Disraeli Pedestrian Bridge Study

Cycling Pedestrian Crossing Collaborative Planning Process -- Results of Charette

Option 2: Separate Crossing

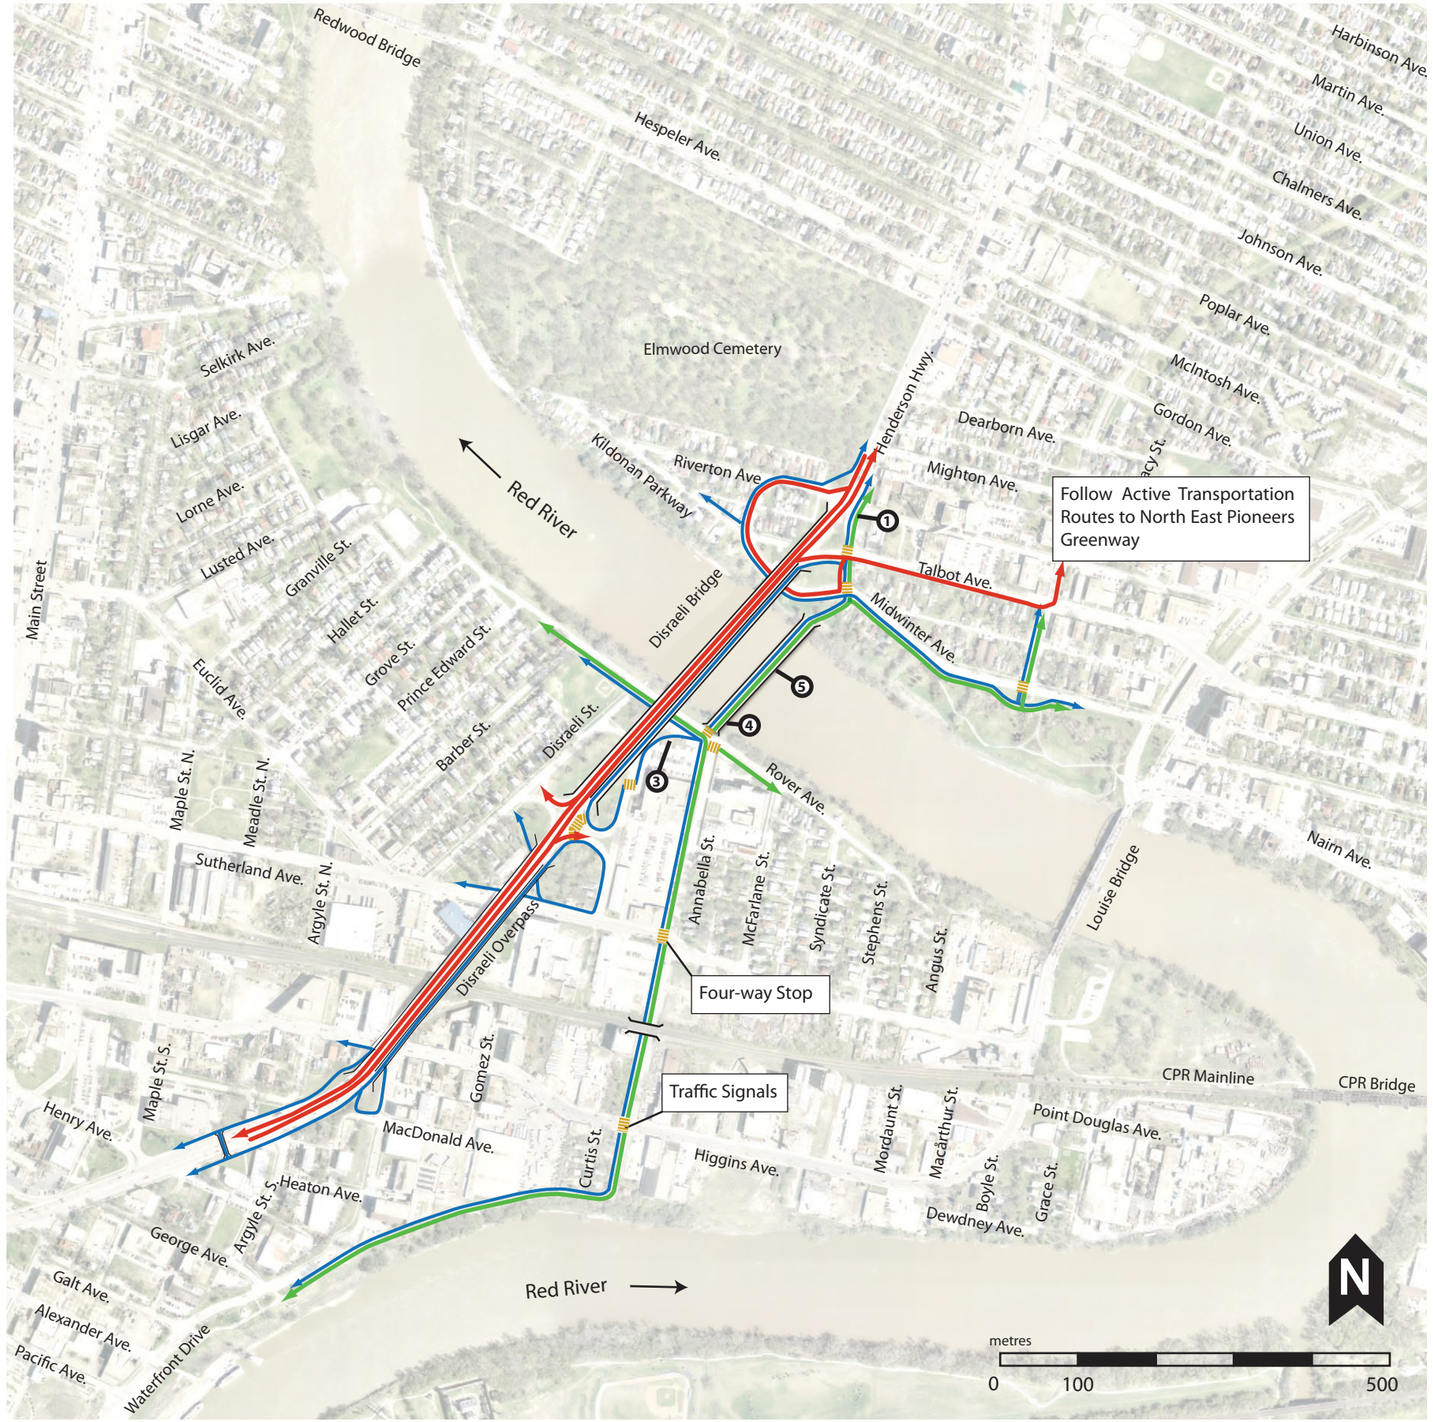
① Link to Henderson needs to be multi-use, not pedestrian-only as indicated by charrette group. Potential pedestrian actuated signalized crossing.

② Longer ramp required on south side of bridge rather than that shown on charrette drawing. Spiral ramp is one potential solution.

③ May be property issues on south side.

④ No structures in the water within the contamination plume - may limit ramp options.

⑤ Charrette group identified 5m width for separate bridge. City of Winnipeg has set minimum width as 3.5m. Proponents will earn points for wider bridge. Widenings at bridge piers will also earn extra points.
